# SITE PLAN REVIEW

LOT NO. 20 REGISTERED PLAN 43M-2122

LOT №.	0	DRAWING TITLE: SITE PLAN
DATE MAR Ø8/	22	PROJECT NAME : YALES OF HUMBER
SCALE 1:250		
DO DO		CLIENT NAME :
PROJECT No 19-277		ROYAL PINE HOMES

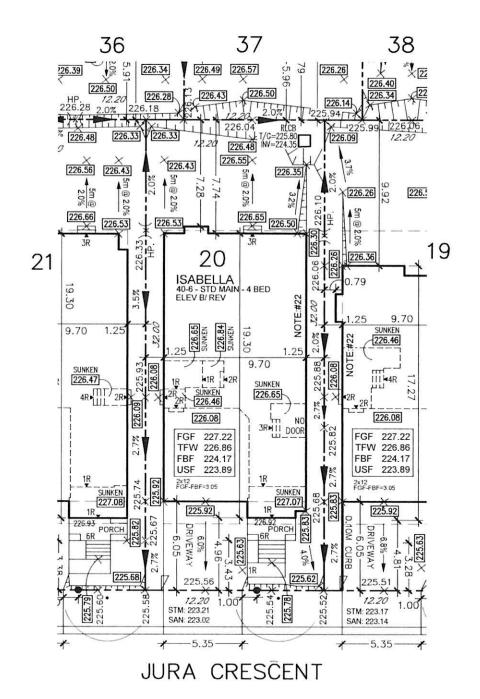
UNDERGROUND SERVICES WERE NOT CONSTRUCTED WHEN SITEPLAN WAS APPROVED.
